**BERGENFIELD ZONING BOARD OF ADJUSTMENT
REGULAR MEETING
TELECONFERENCE VIA ZOOM
February 1, 2021 8:00 PM**

Application: 145 West Main Street, LLC
145 West Main Street
Change of use to a multi-family dwelling R-5 zone to RM zone
Carried over from January 11, 2021 meeting.

SITE PLAN OF PROPOSED RESIDENTIAL BUILDING
LOT 6.01, 6.02 & 6.03 BLOCK 106 ZONE R-5

SITE PLAN

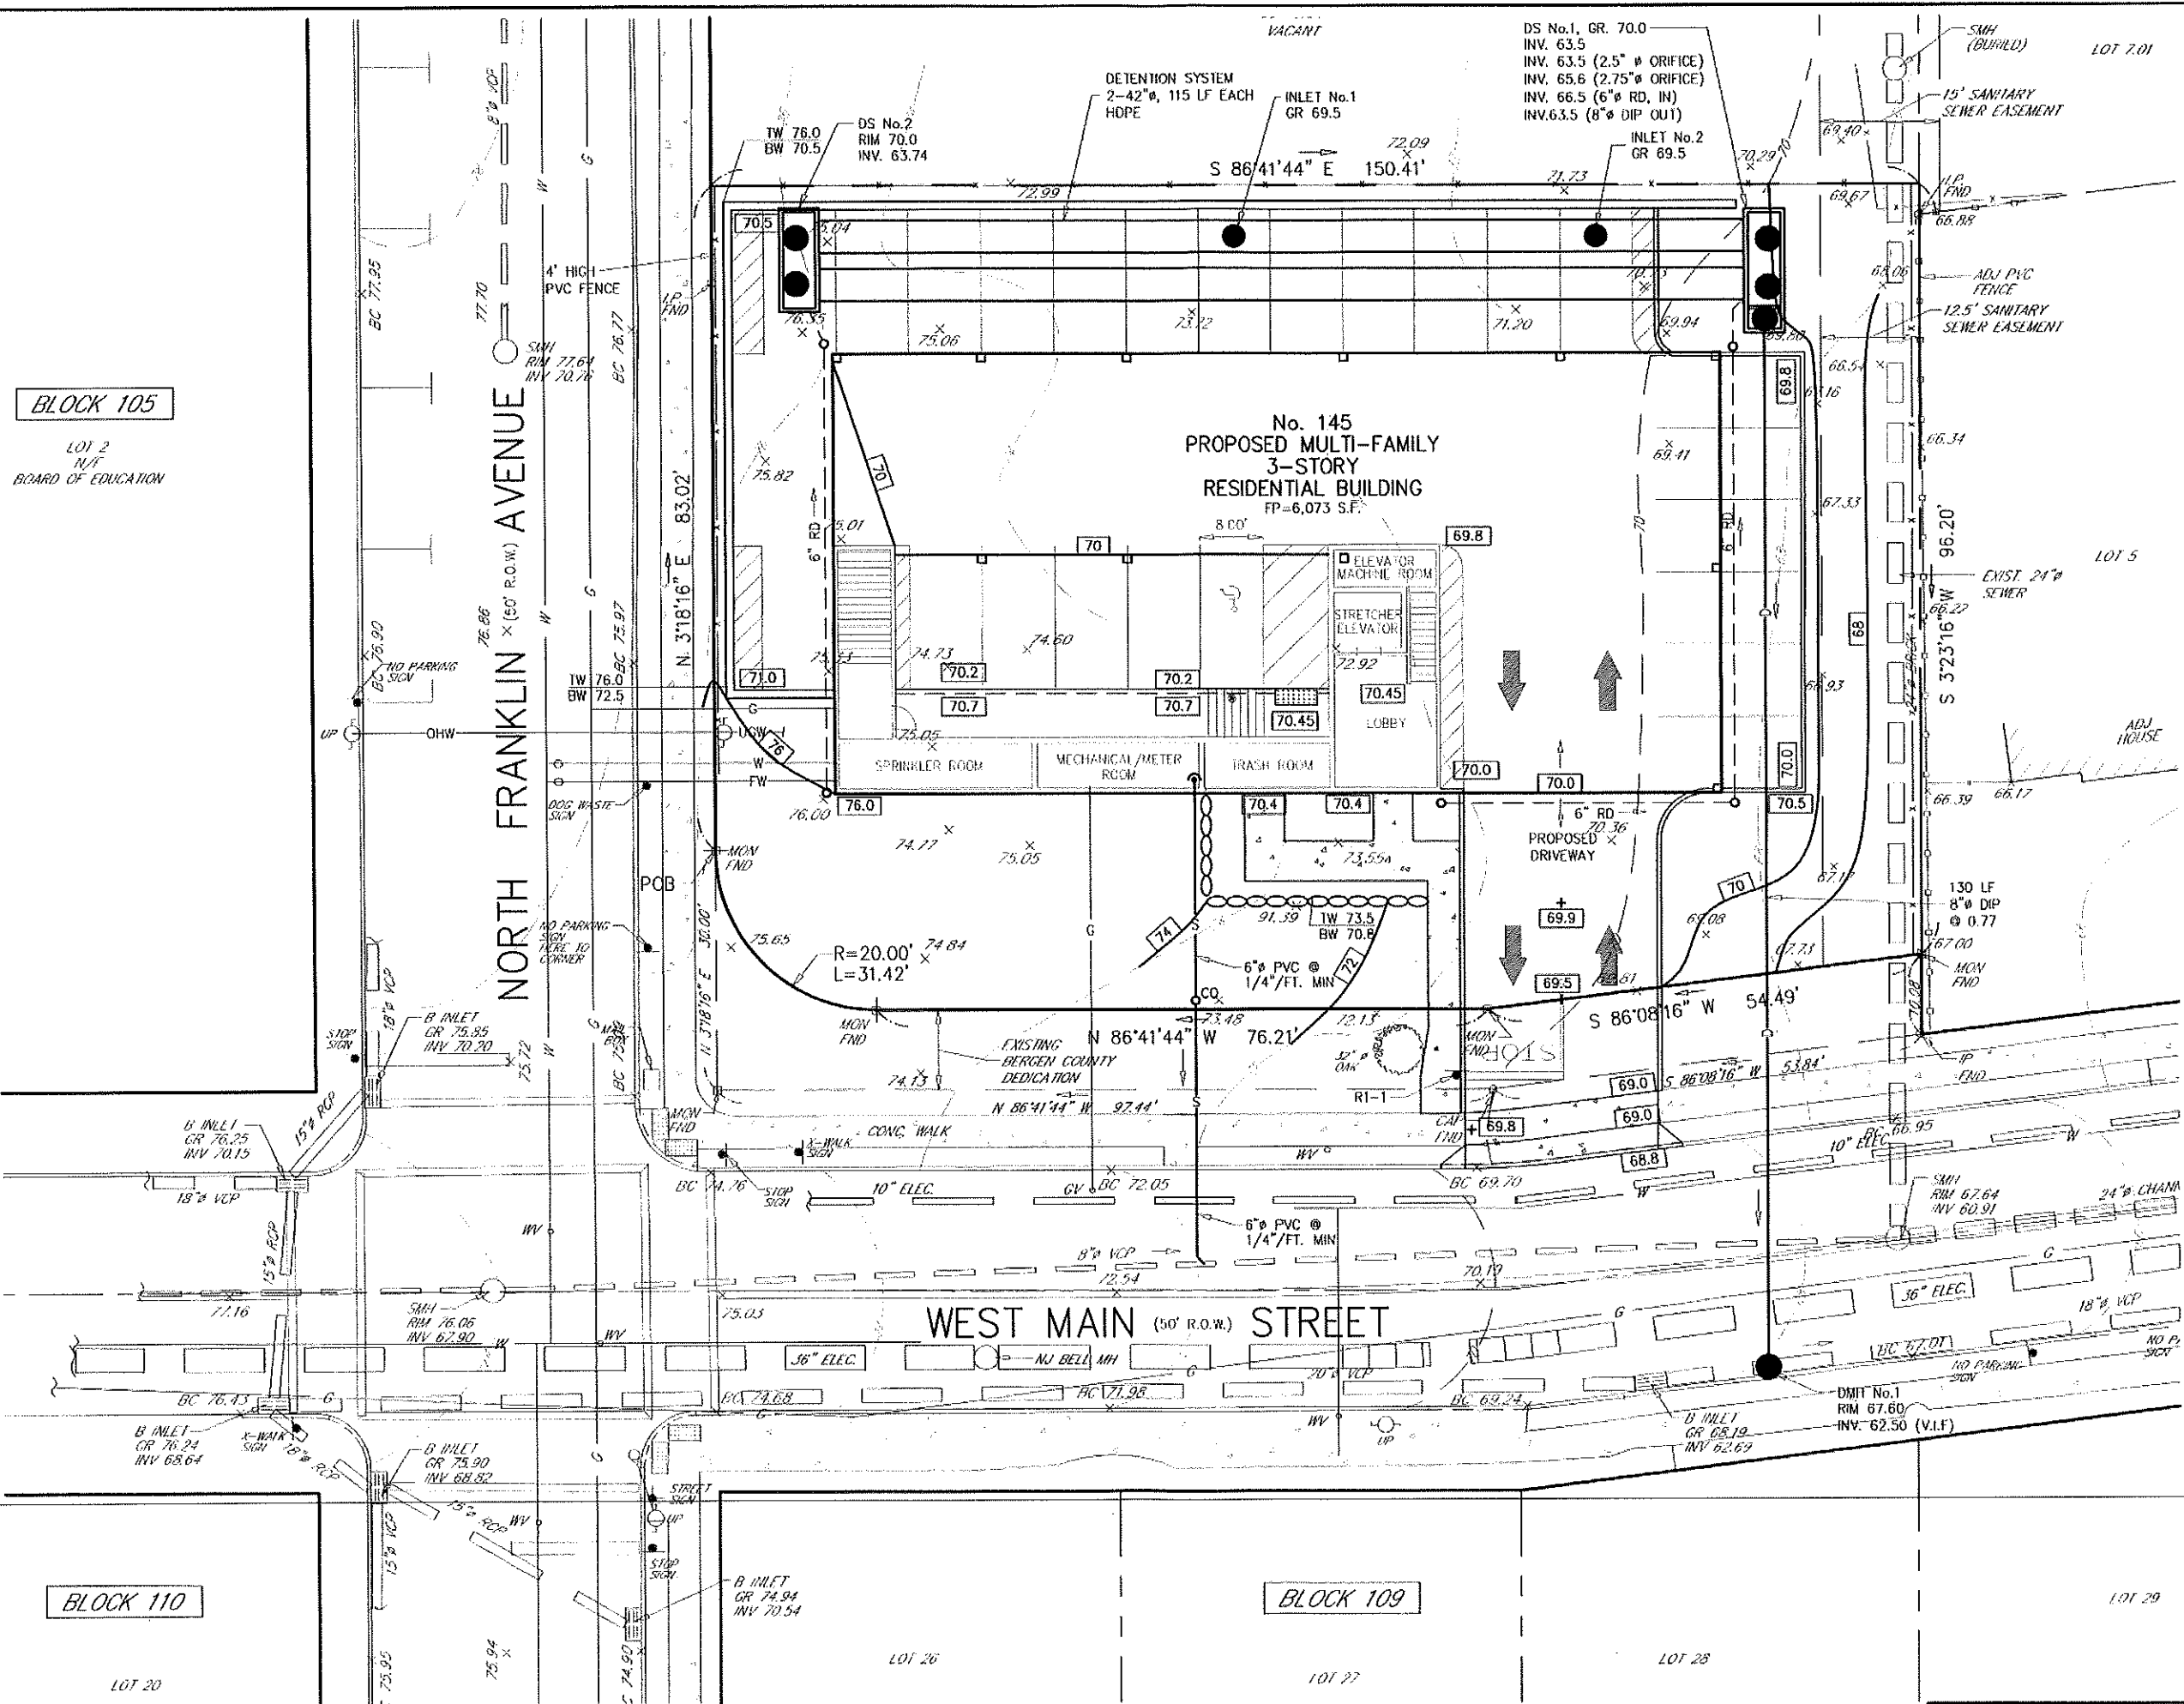
1. Change of use from R-5 to RM Zone.
2. Maximum density 12 units per acre 43,560 sq. feet. Proposed 16 units on 14,469 sq. feet.
3. Minimum front yard setback R-5 & R-6 25 sq. feet. Proposed front yard 22.9 sq. feet.

4. Minimum rear yard setback R-5 & R-6 25 sq. feet. Proposed rear yard 20 sq. feet.
5. Maximum lot coverage allowed R-6 over 6,000 sq. feet or 30%. Proposed lot coverage 43.38 %.

6. Maximum total improved lot coverage R-6 over 6,000 sq. feet or 35%. Proposed lot coverage 70.91%
7. Required multi-family dwelling units set back 35 sq. feet from front property line and a least 25 sq. feet from any other property line or from curb to street. (see 186-57 yards). Proposed 22.9 sq. feet front yard, 15 sq. feet from both side yards.

8. 186-55 design requirements, site plan for any multi-family development shall not be less than 20,000 sq. feet. Proposed 14,469.44 sq. feet.
9. Minimum required parking for occupants only 32 spaces not including visitor spaces. Proposed 25 parking spaces including two (2) handicap spaces.

**FIGURE 1 – Crash Data
145 West Main Street**

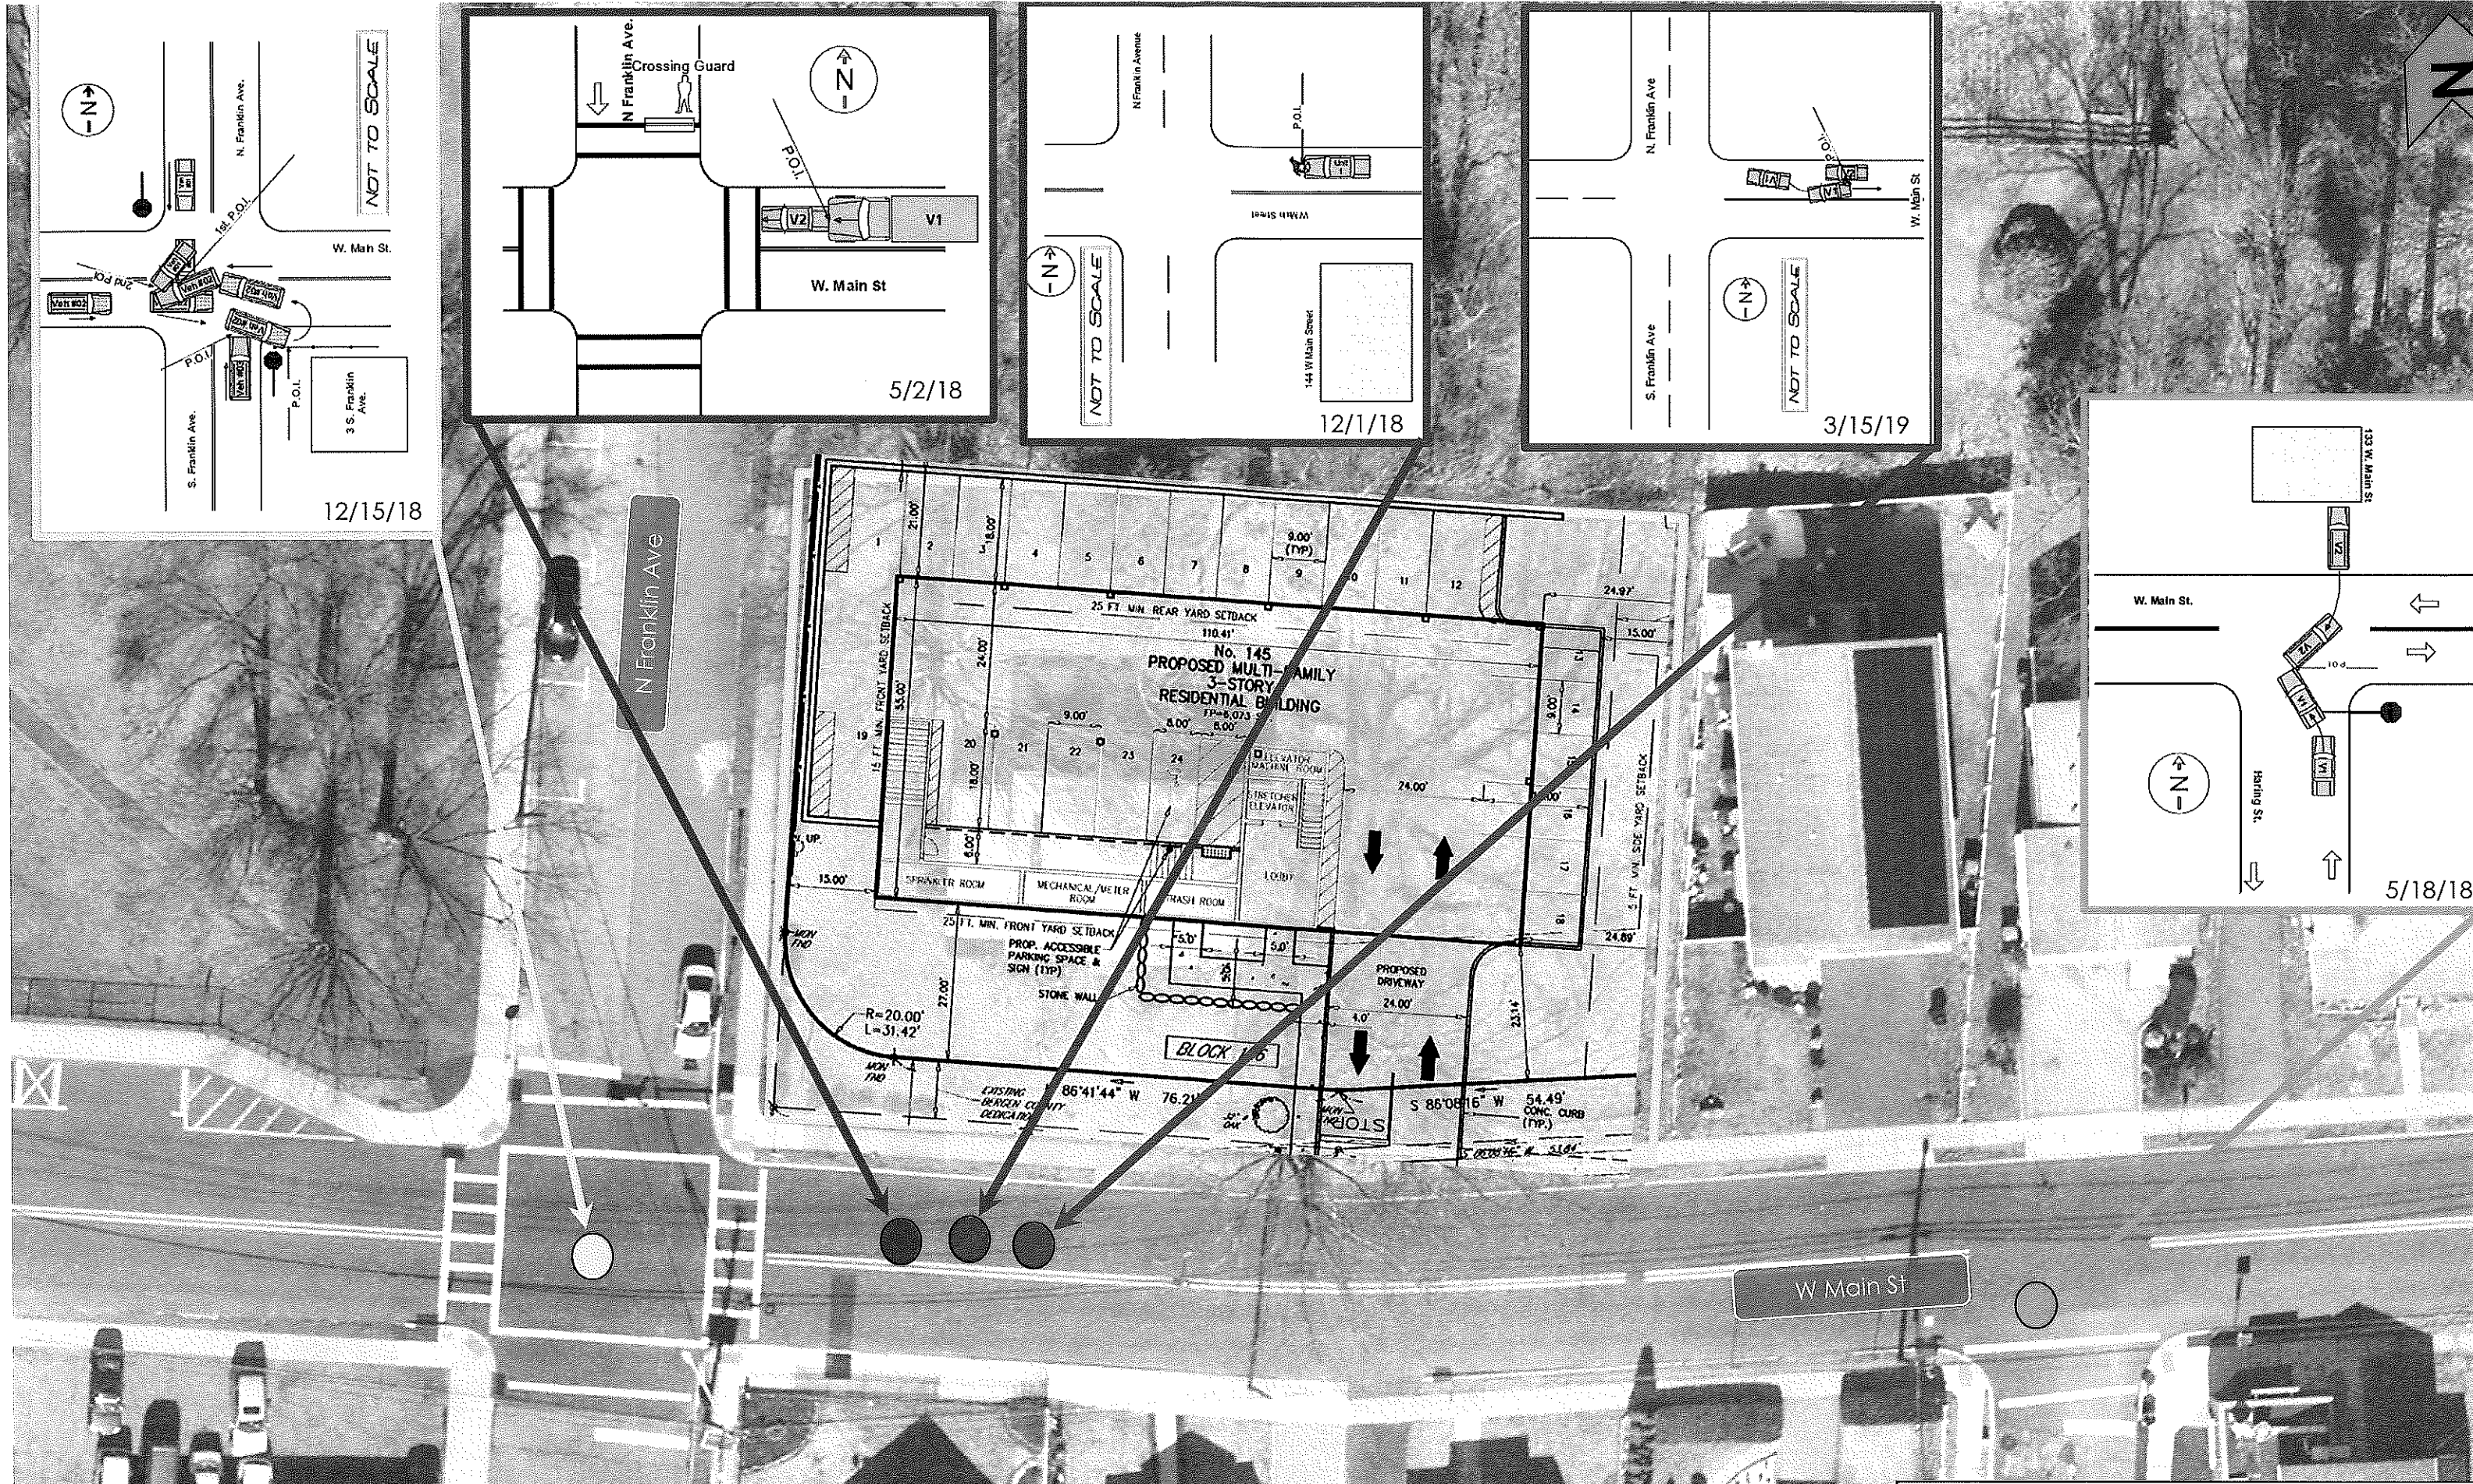
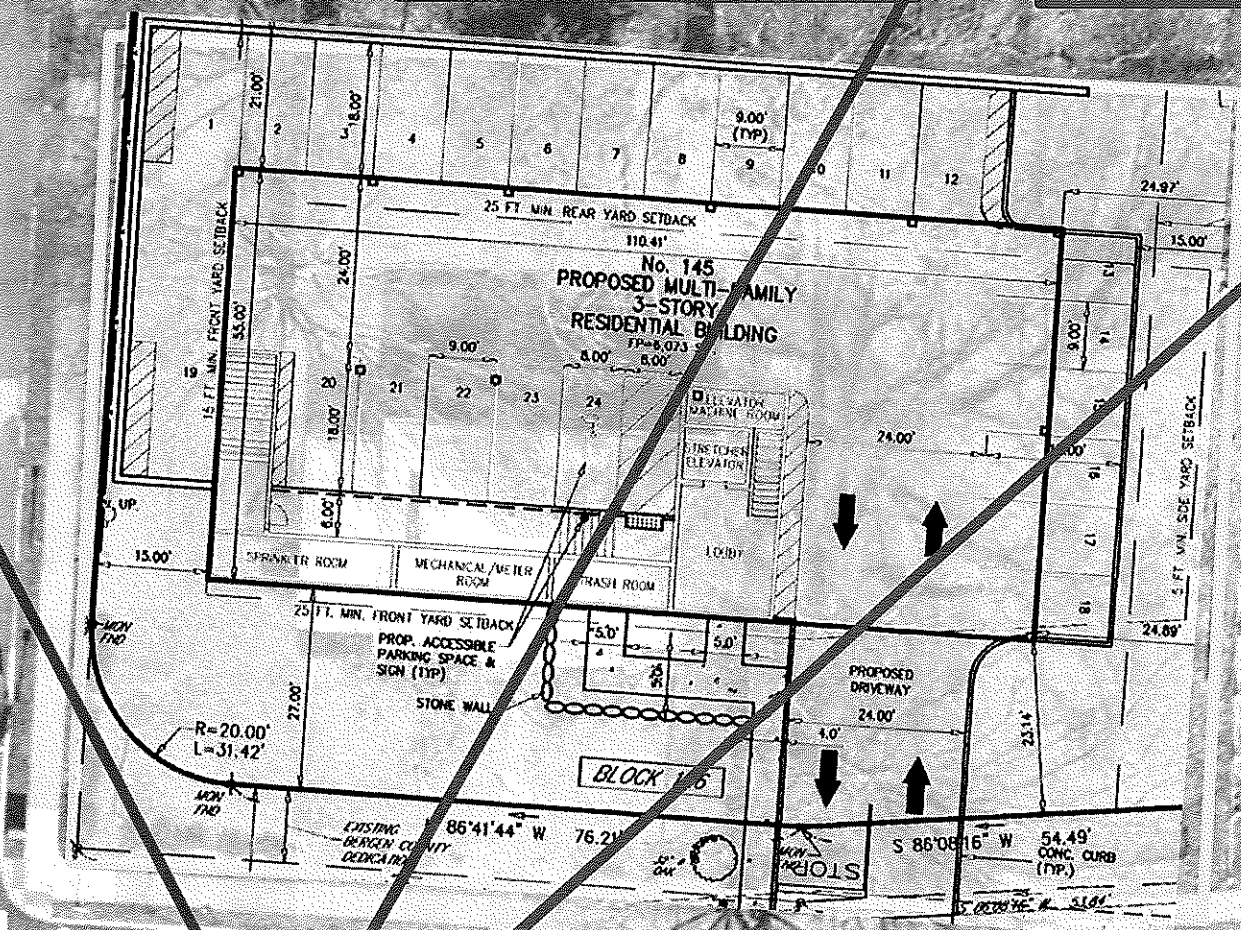
4. **Findings based upon receipt of accident data** - We requested copies of all crash reports along the segment of W. Main Street, between N. Franklin Avenue and Haring Street for the past three years (2019, 2018, and 2017). **FIGURE 1** shows a summary of crash data received. There was a total of six crash reports ranging from intersection to animal interactions. These crash reports do not have any correlation to the proposed driveway along W Main Street.

**FIGURE 1 Driveway Locations
145 West Main Street**

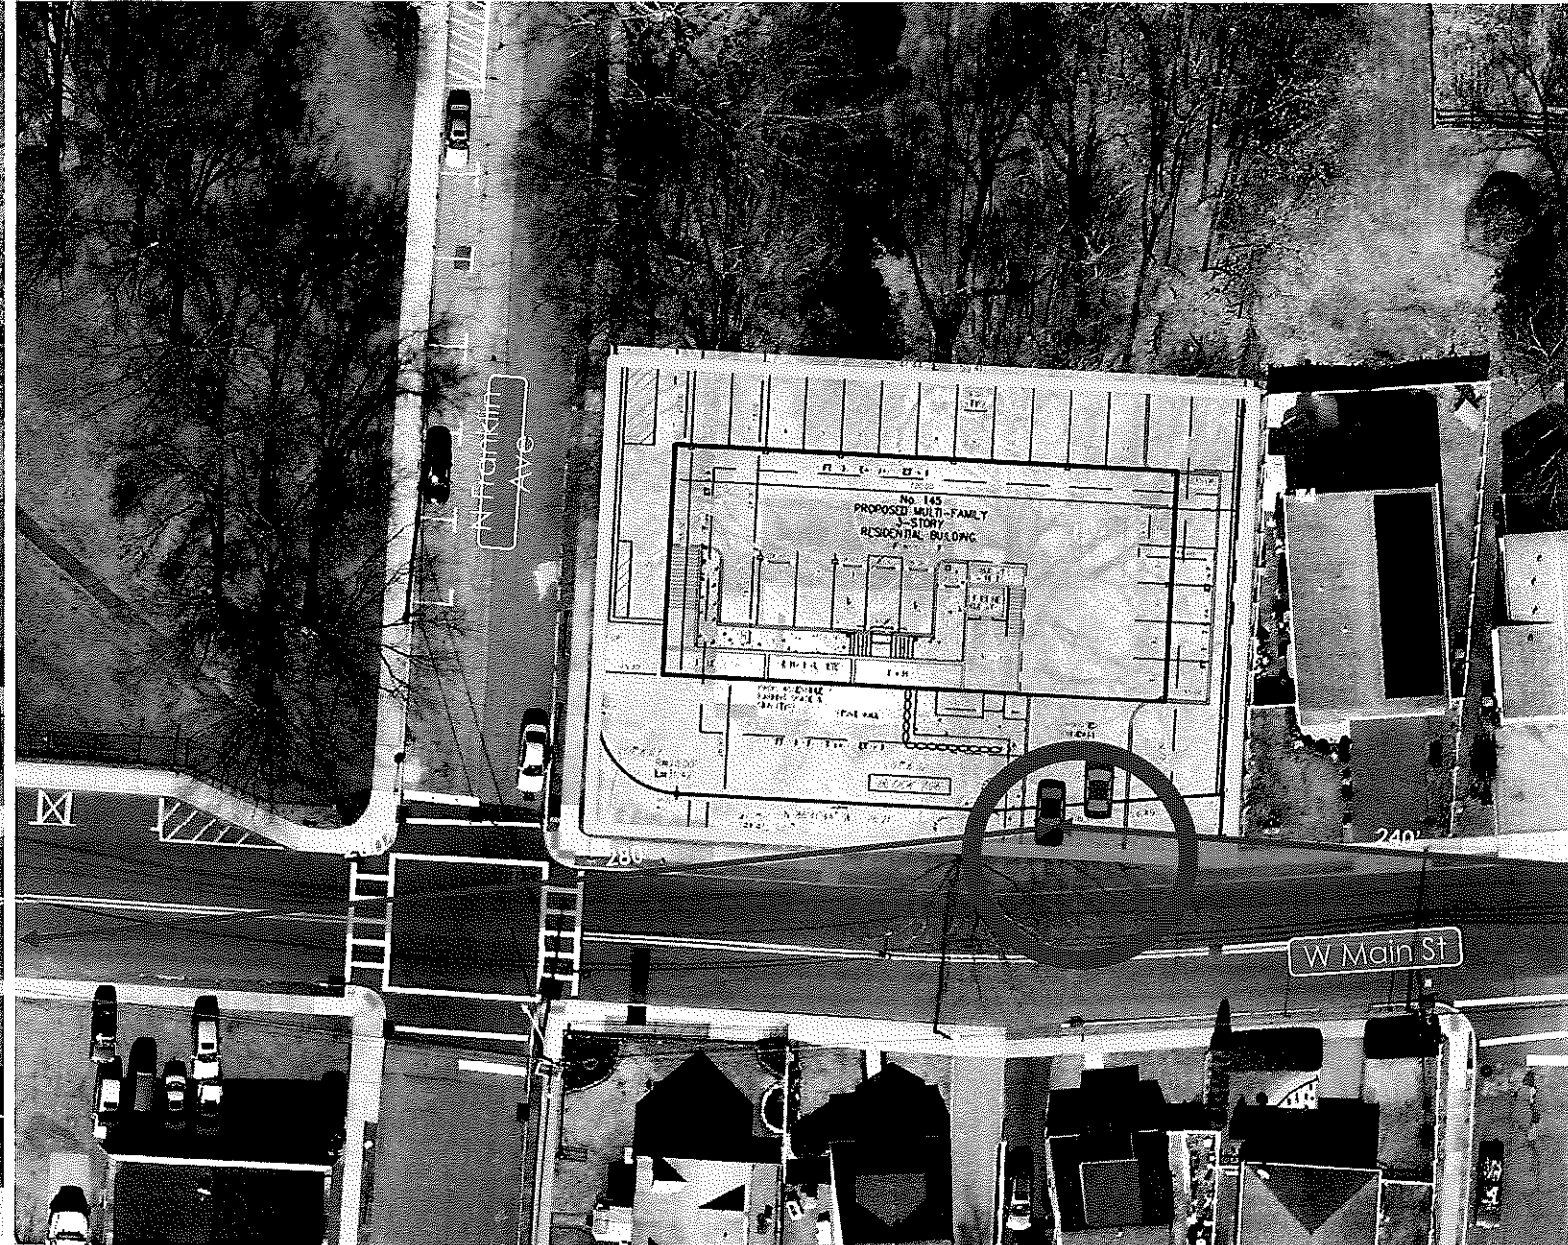
5. **Revised driveway location** – The revised proposed driveway location along W Main Street would be safe and efficient. The proposed driveway could provide pedestrian signal heads across the proposed driveway / sidewalk to increase pedestrian safety and awareness. In addition, there also could be prohibitions on left turns in and out of the proposed driveway. The proposed driveway should not be in conflict with existing driveways across W Main Street as the roadway provides for sufficient width.
